ADDENDUM

ADDENDUM # 5

Bid 20C10, Multi-Classroom Portable Unit for Oakdale Elementary School

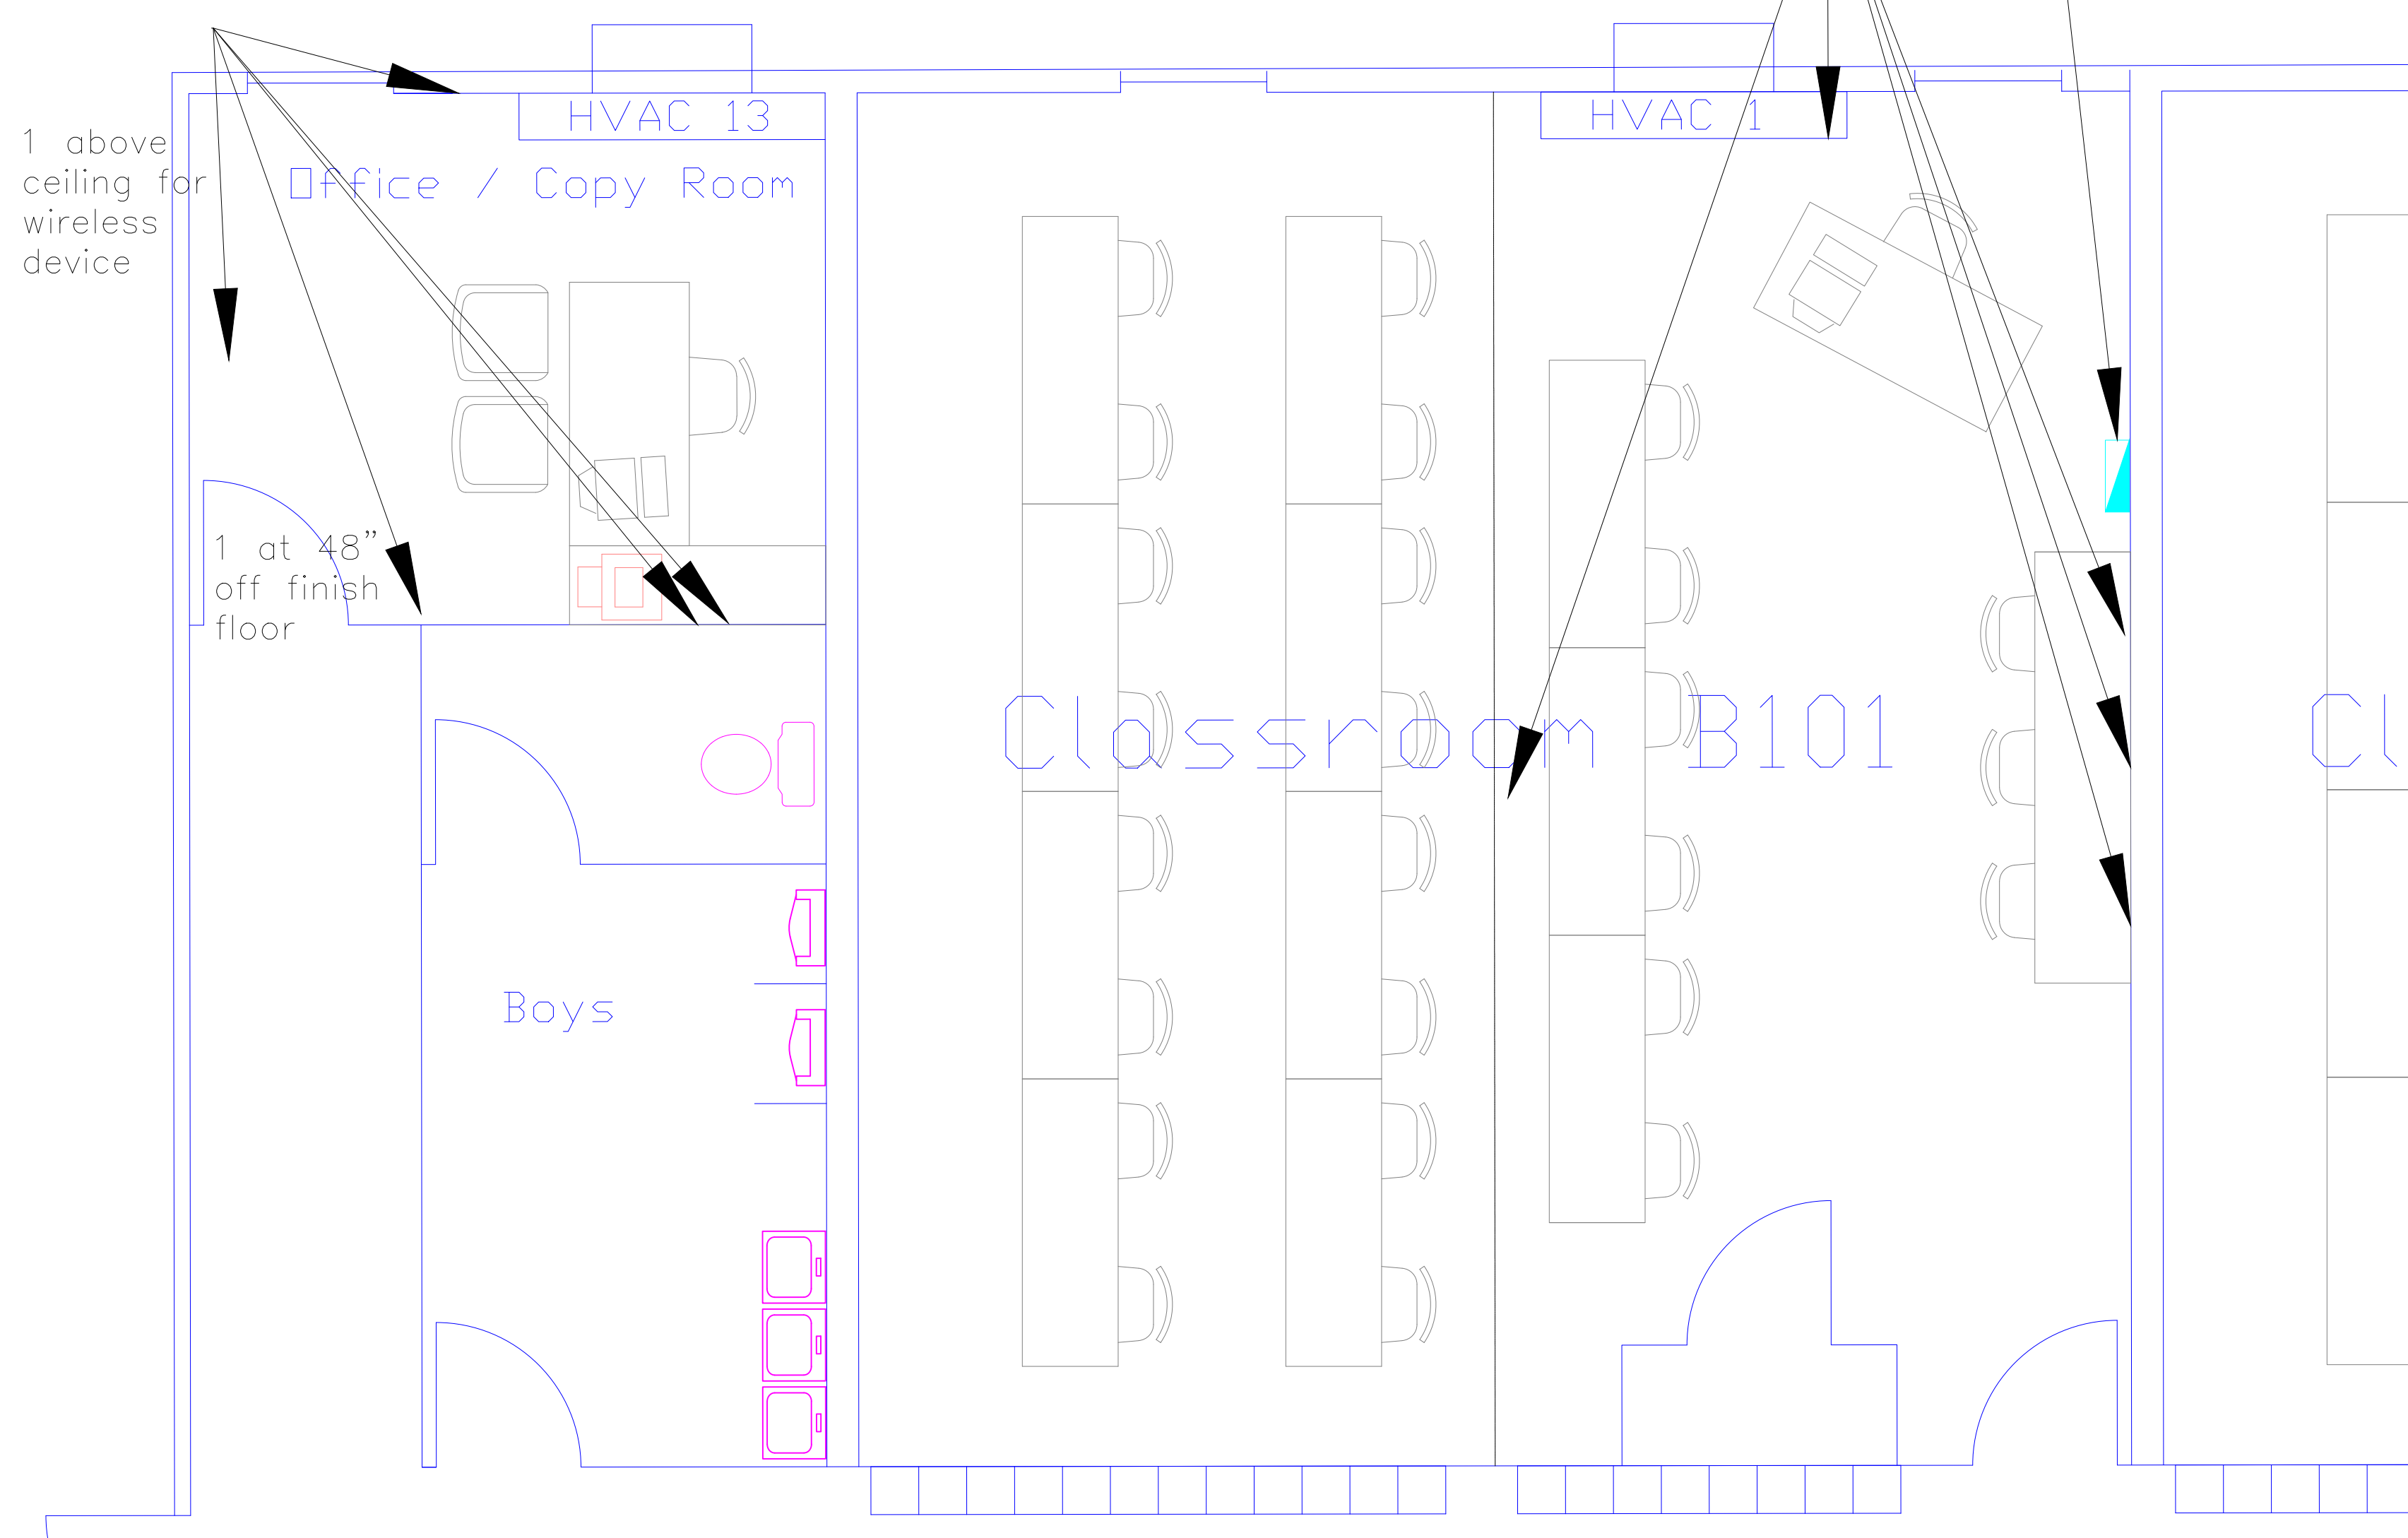
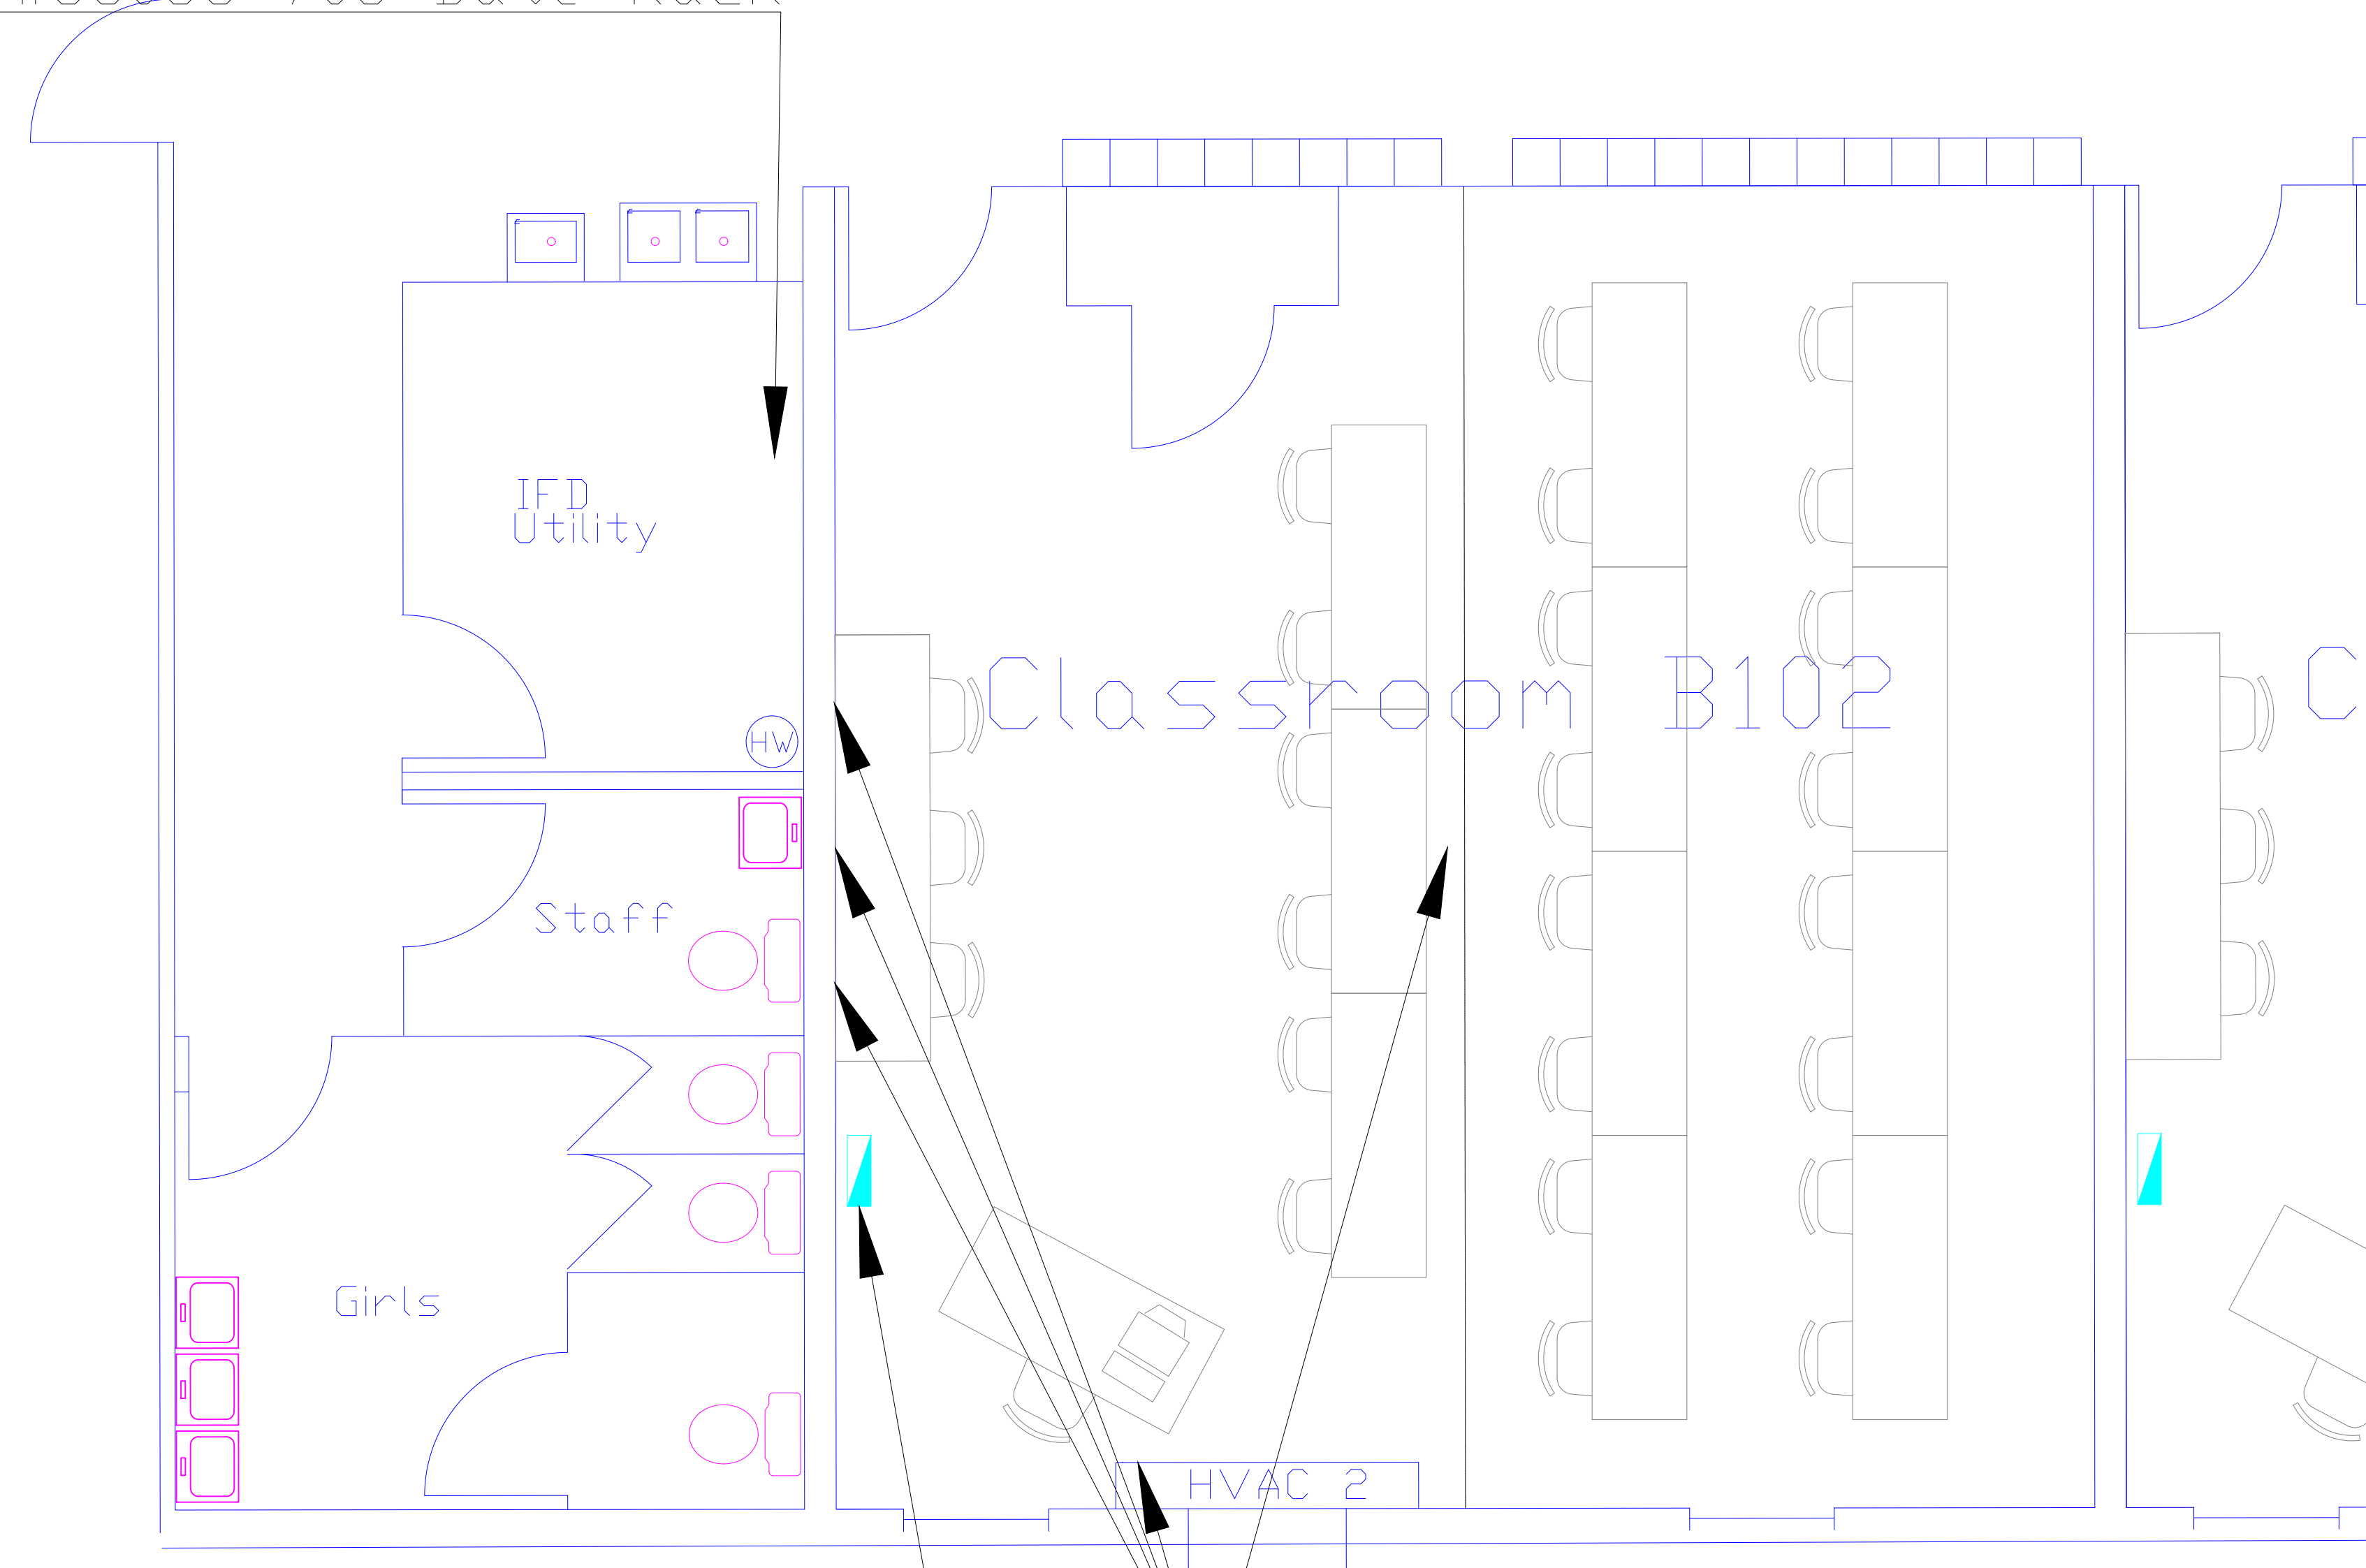
The Contractor shall install one (1) ThinLine cabinet 26x26x5 2RMU BK Catalog # 13050-711 with Fan Kit 2U ThinLine Catalog # 13051-002 including a duplex-receptacle connected to the modular classroom distribution panel (see Portable Data Drop Location Model drawing). Fiber Optic cabling to each modular provides Data & Telephone distribution. Spliced cabling will not be accepted for telephone or data connections. Chatsworth ThinLine part #13050-711 Chatsworth Fan part# 13051-002

Yes Five Data outlets are required in the Office / Copy Room.

Office Data from IDF outlets and 110v

Typical Data Box

Typical Data outlets and 110v receptacle in classrooms, one data drop near center of classroom above ceiling.

Install Chatsworth #55053-703 Date Rack

Typical Data outlets and 110v receptacle in classrooms, one data drop near center of classroom above ceiling.

Typical Data Box
